Site Accessibility Evaluation Americans with Disabilities Act Title II (Public Services: State and Local Government)

**CITY HALL BUILDING
200 Lincoln Avenue
Santa Fe, NM 87501**

Report Date: 02/03/2025

Exterior Site : E1 Curb Ramp at Federal and Lincoln Crossing Lincoln Avenue

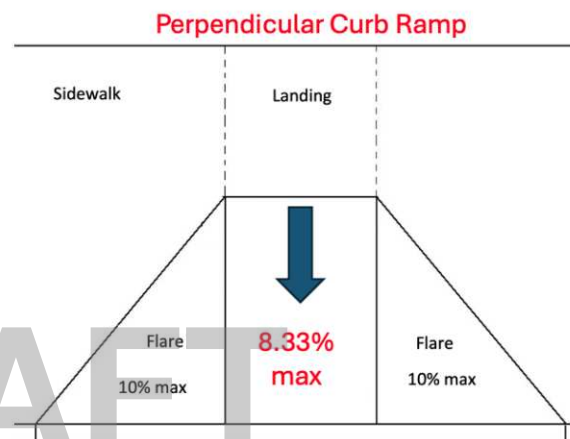
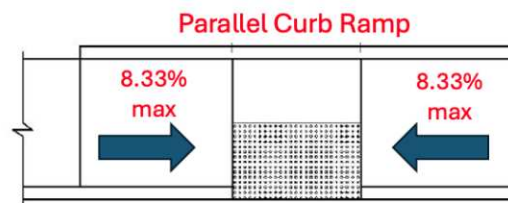
The curb ramp exceeds the maximum running slope (parallel to the direction of travel) allowable of 8.33%.

Curb ramps should have the least possible slope but in no case more than 8.33% (1:12).

8.6%

Exterior Site : E2 Bus Stop on Lincoln Avenue

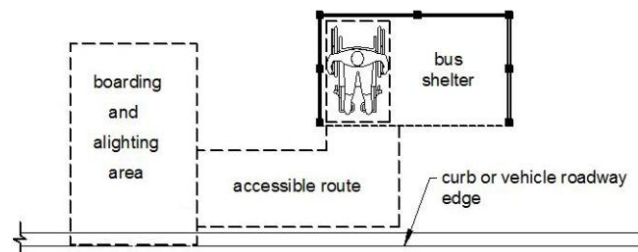
The bus stop shelter does not provide room for a wheelchair user.

Bus shelters shall provide a minimum clear floor or ground space entirely within the shelter.

Remove existing bench.

Exterior Site : E5 Path of Travel Along Marcy Street

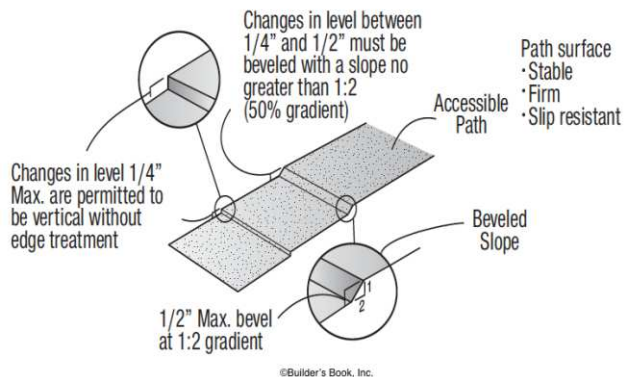
The accessible route contains loose gravel and/or surface materials that do not provide for a stable, firm slip resistant surface.

The brick paved sidewalk has very few areas of irregular pavement. This Accessible route is acceptable.

Exterior Site : E6 Path of Travel from Lincoln Avenue and Marcy Street to South Entrance

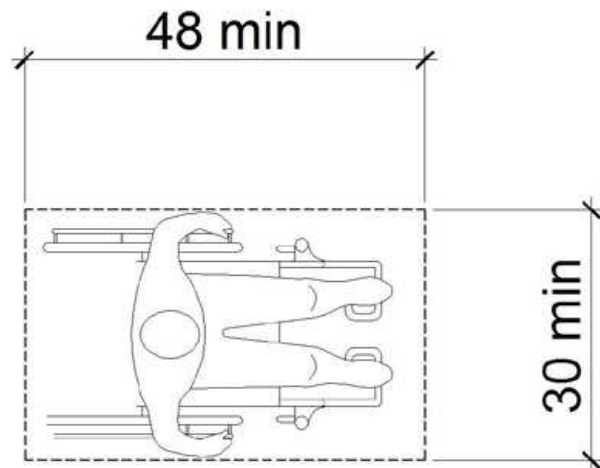
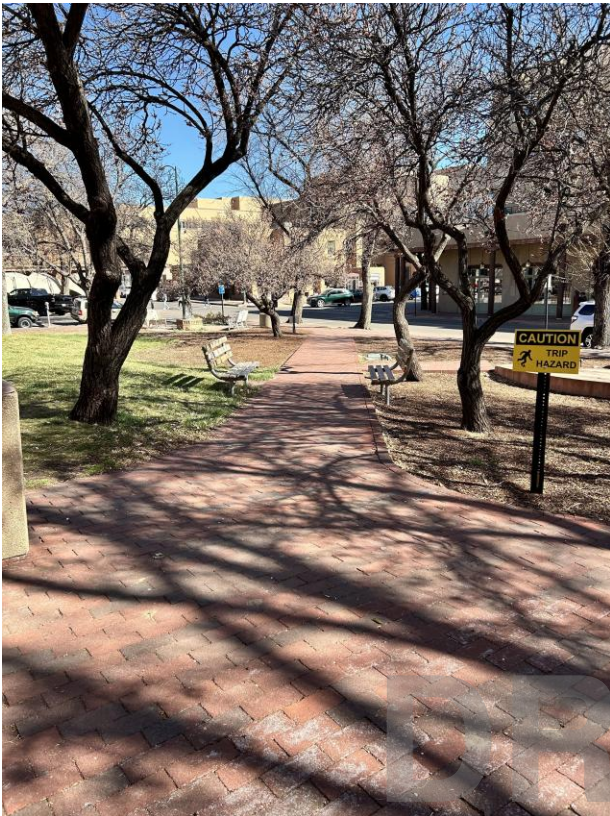
The required clear floor space is not wide enough.

Existing fixed bench does not provide the clear space at one end of the bench.

Exterior Site : E6 Path of Travel from Lincoln Avenue and Marcy Street to South Entrance

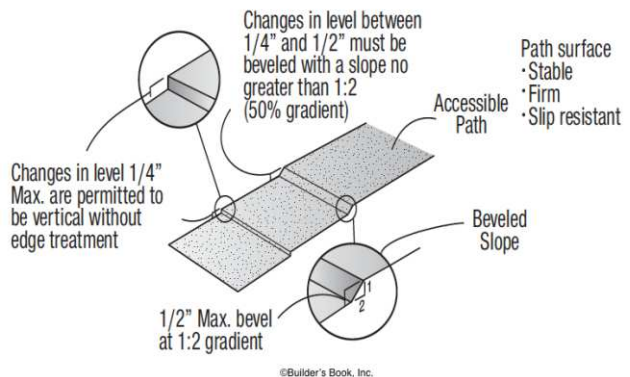
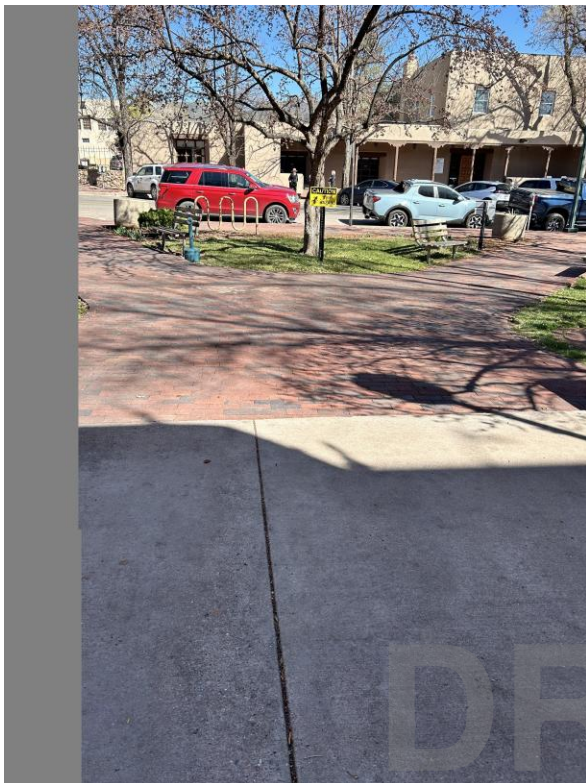
The accessible route contains loose gravel and/or surface materials that do not provide for a stable, firm slip resistant surface.

Existing Brick walking surfaces are irregular.

Exterior Site : E7 Path of Travel from Marcy Street to West Wing Entrance

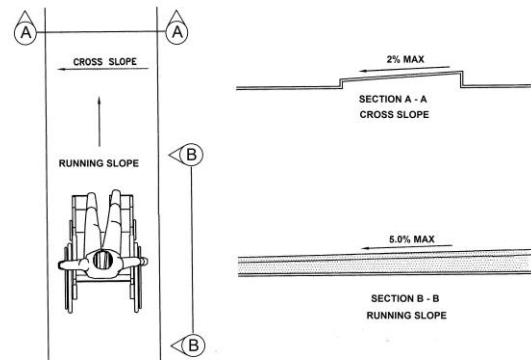
The accessible route of travel on the walk or sidewalk has cross slopes greater than 2%.

Exiting slope is greater than 8.33% and the brick pavement is irregular

Exterior Site : E8 Path of Travel from Lincoln Avenue to Main Entrance

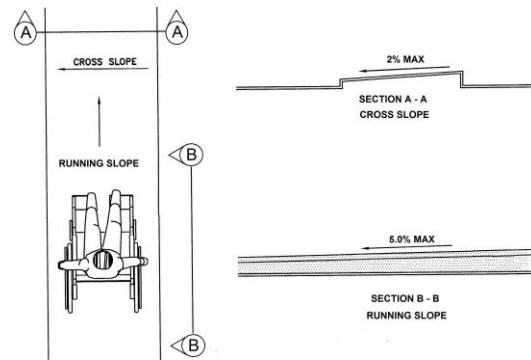
The accessible route has running slopes greater than 5% and has not been constructed as a ramp (i.e. handrails, edge protection, etc.). Cross slopes are greater than 2% across the width of the walk.

Pavement creates abrupt changes in level exceeding or impacting consistency in the accessible route.

Remove, repair or replace abrupt areas.

Exterior Site : E9 Path of Travel to North Entrance

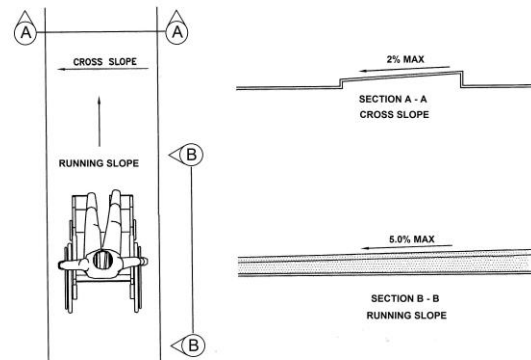
The accessible route has running slopes greater than 5% and has not been constructed as a ramp (i.e. handrails, edge protection, etc.). Cross slopes are greater than 2% across the width of the walk.

Slopes exceed requirements.

Repair slopes or identify accessible route with signage.

Basement Level: B2 Plat Room

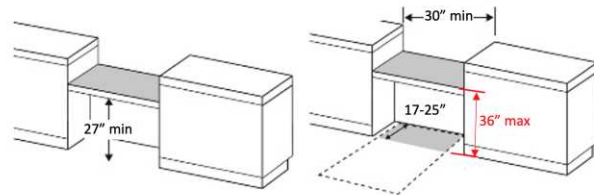
The counter is higher than 36 inches above the floor.

Existing Dutch Door style service counter is 45 inches in height.

Provide an accessible alternative.

Basement Level: B2 Plat Room

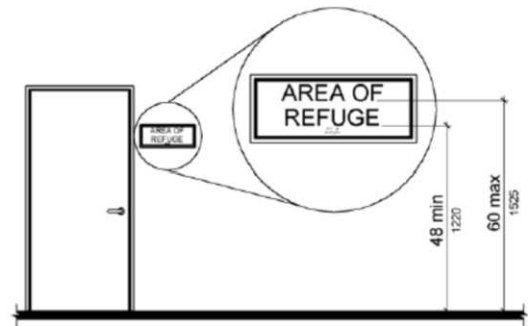
The room identification sign is noncompliant.

Current sign is not accessible.

Install accessible sign

1ST Level: F1 South Side Building Entrance (Council MGTs)

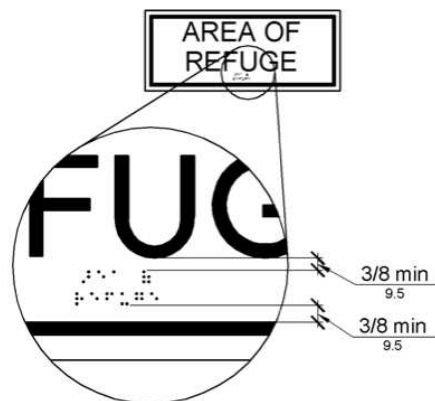
The sign is missing the required Braille.

Existing signage is not accessible

Install accessible signage

1ST Level: F1 South Side Building Entrance (Council MGTs)

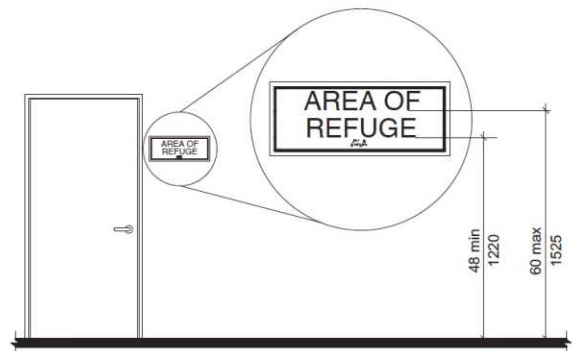
The wall sign is mounted within the required range.

Existing signage is 60 inches above floor.

Install at required height.

1ST Level: F1 South Side Building Entrance (Council MGTs)

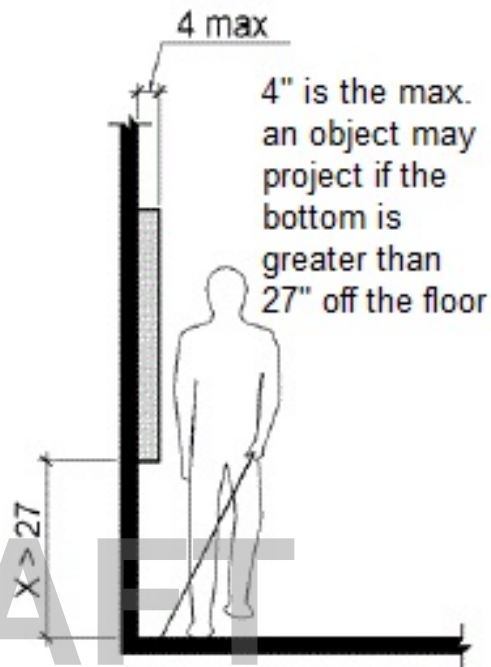
The (XX) projects more than 4 inches into the circulation path.

Suggestion box extends 5 inches

Remove box and any others

1ST Level: F2 Ramp and Stairs to Main Corridor

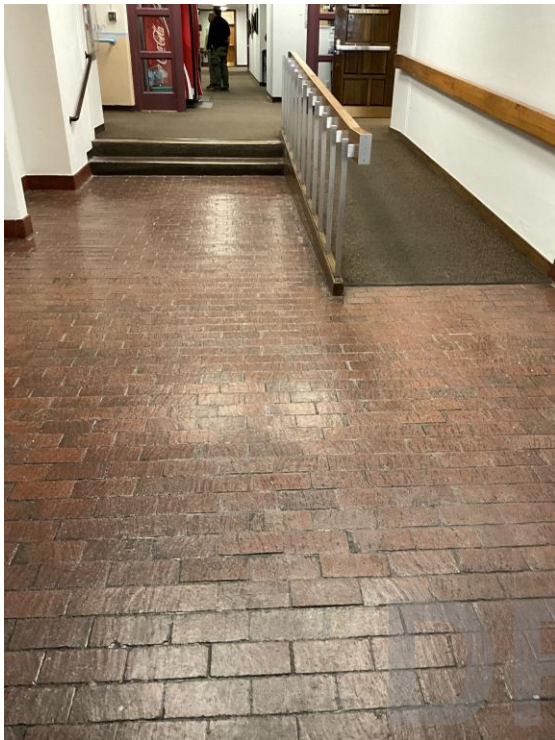
Finding: 19 - Stairs do not provide a 2" wide contrasting color strip 1" from nosing on top and bottom treads.

Install contrasting color strip.

1ST Level: F4 South Stairs

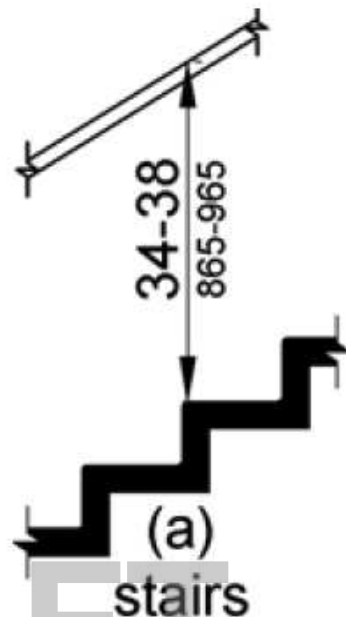
The handrails are not at the correct height.

Existing handrail height is 31" above finished floor

Provide new handrails

1ST Level: F4 South Stairs

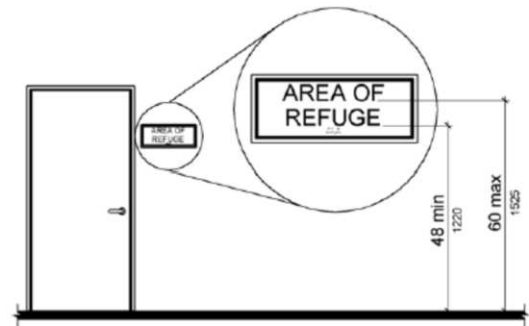
Compliant room identification signs are missing.

No signage

Install accessible signage

1ST Level: F6 City Manager's Office #102

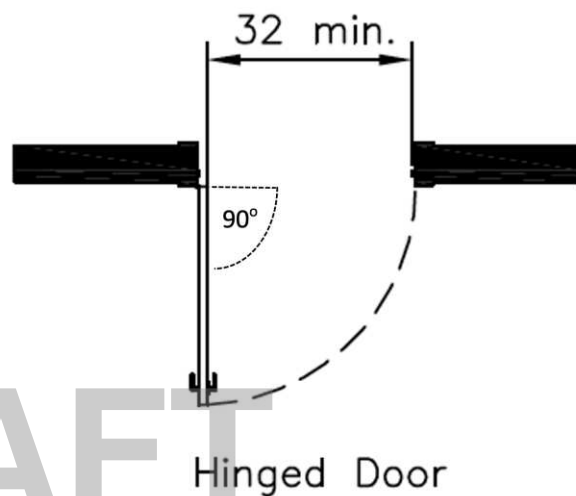
The door opening does not provide at least 32 inches between the face of the door and the opposite stop.

Existing door has a 21" clear opening width.

Widen door.

1ST Level: F6 City Manager's Office #102

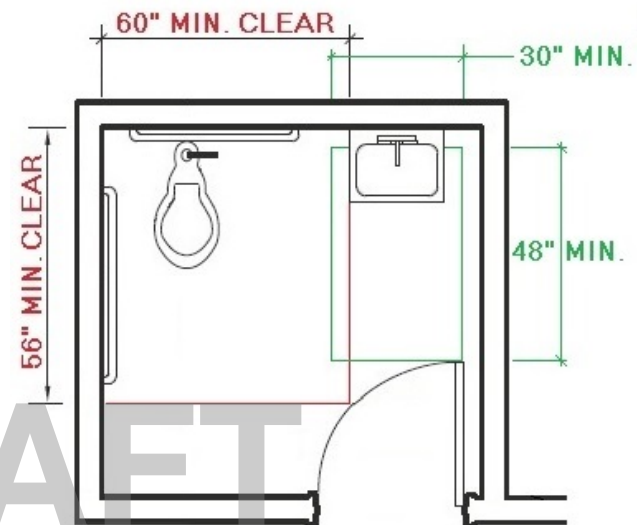
The restroom is not nearly compliant.

The restroom does not have the required minimum clear floor space or maneuvering clearances for the toilet. The restroom does not have the required minimum clear floor space or maneuvering clearances for the lavatory. The entry door does not contain the required minimum maneuvering spaces on the pull/push sides. The entry door encroach into the required clear floor space for fixtures. Grab bars are missing and/or incorrectly installed. Accessories, such as toilet seat covers, paper towel holders, garbage cans, hand dryers, and mirrors are either too high or without clear floor space or both. The restroom contain floor level changes greater than a 1/2 inch of the floor drains and is slope (XX) - (XX), the shower is too small and missing numerous accessible elements.

Single accommodation restroom is not accessible.

1ST Level: F7 City Manager's Office

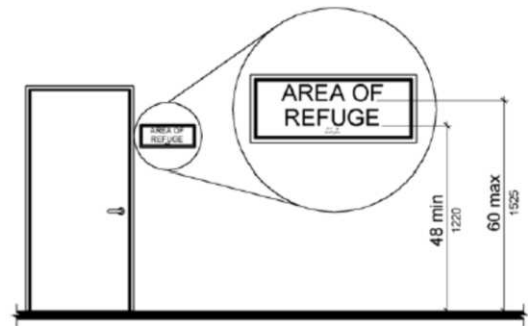
Compliant room identification signs are missing.

Existing signage is non-compliant

1ST Level: F8 City Councilor's Office #119

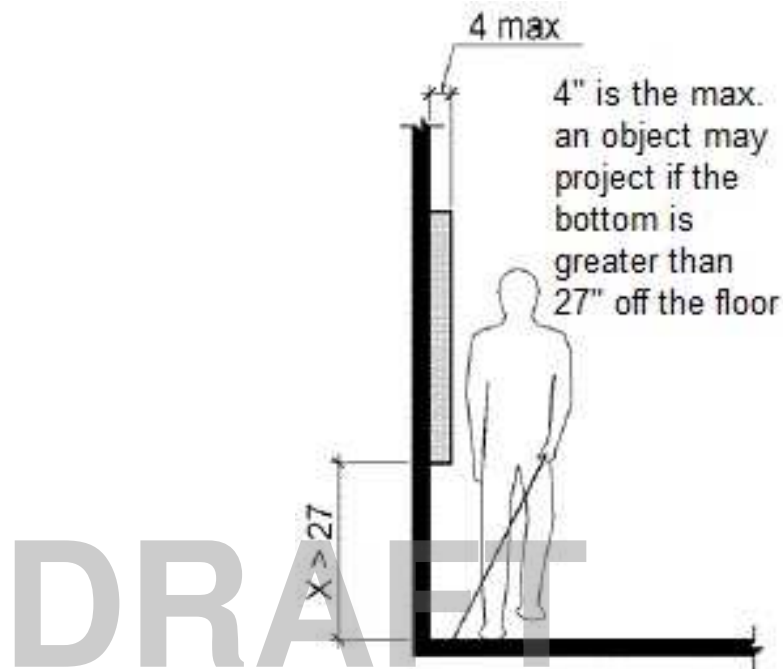
The element projects more than 4 inches into the circulation path.

Shelf is protruding 12" at a height of 55"

Remove shelf.

1ST Level: F8 City Councilor's Office #119

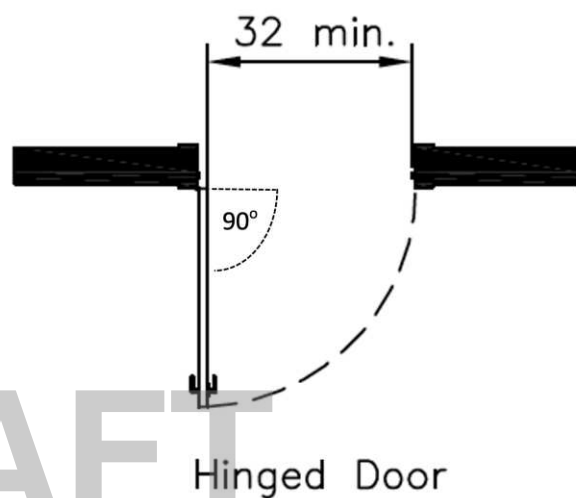
The door opening does not provide at least 32 inches between the face of the door and the opposite stop.

Existing door width is 29"

Widen doorway.

1ST Level: F11 Corridor and Ramp to Council Chambers

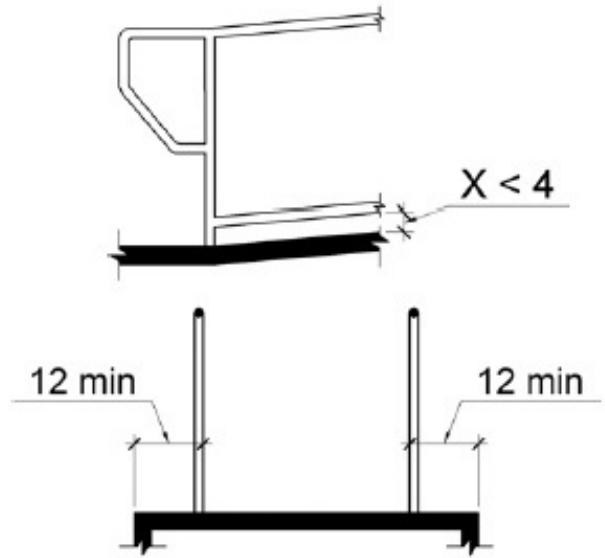
The required edge protection is missing from the ramp run and/or ramp landing.

1ST Level: F11 Corridor and Ramp to Council Chambers

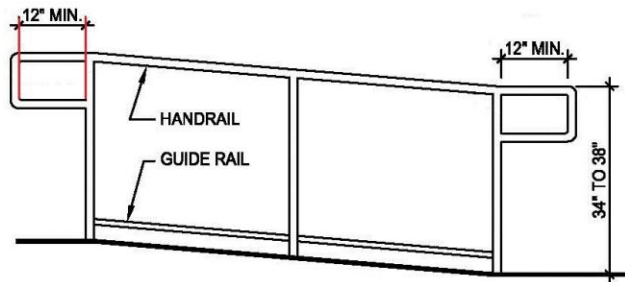
The handrail does not extend past the ramp.

1ST Level: F11 Corridor and Ramp to Council Chambers

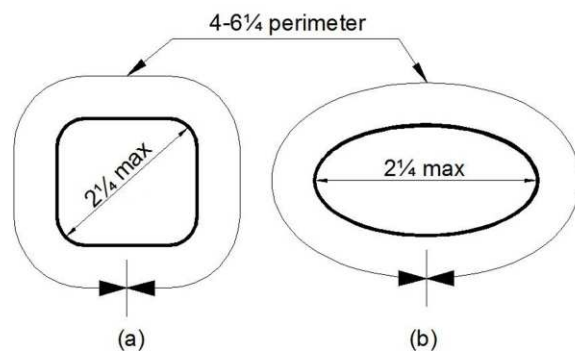
The handrail gripping surface outside perimeter is not within the allowable required range.

1ST Level: F12 Council Chambers

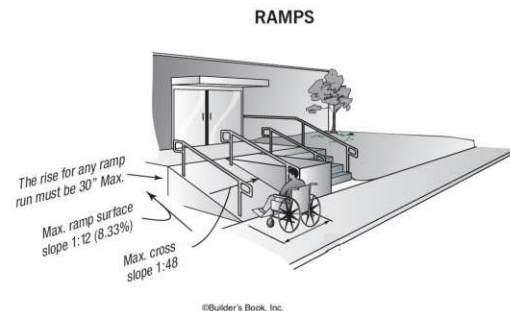
The ramps exceeds the maximum running slope (direction of travel) allowable of 8.33%.

1ST Level: F12 Council Chambers

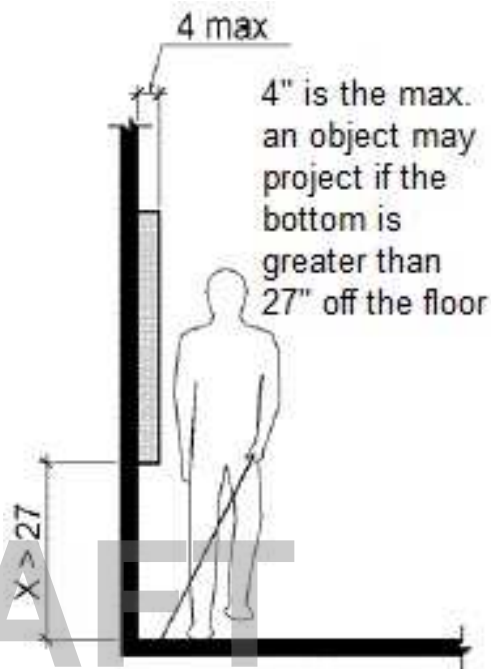
The element projects more than 4 inches into the circulation path.

Fold out podium projects with no cane detection less than 27 inches

1ST Level: F12 Council Chambers

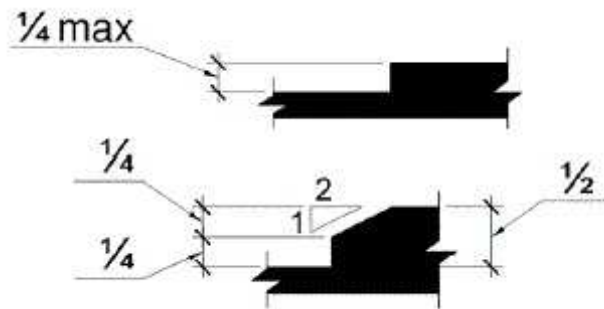
There is a change in level that exceeds the allowable range.

No accessible route to die

1ST Level: F12 Council Chambers

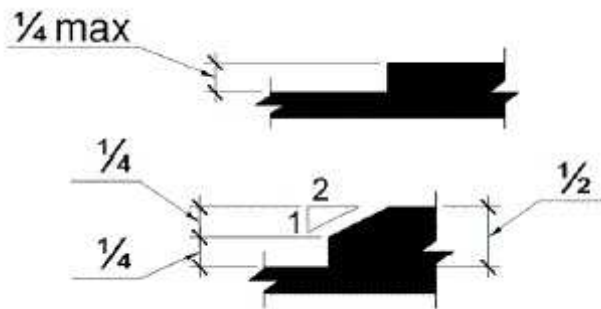
There is a change in level that exceeds the allowable range.

No accessible route to die

1ST Level: F12 Council Chambers

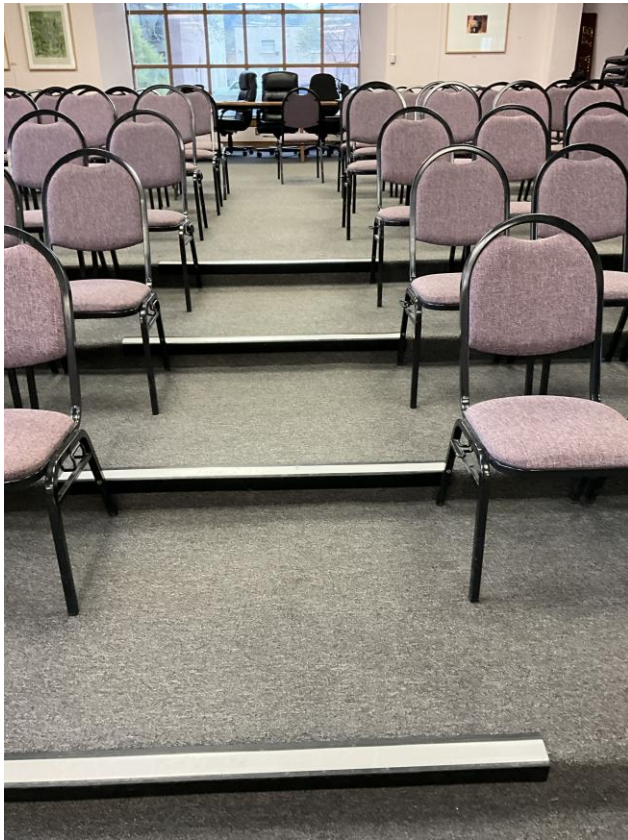
The stairway only has a handrail on one side.
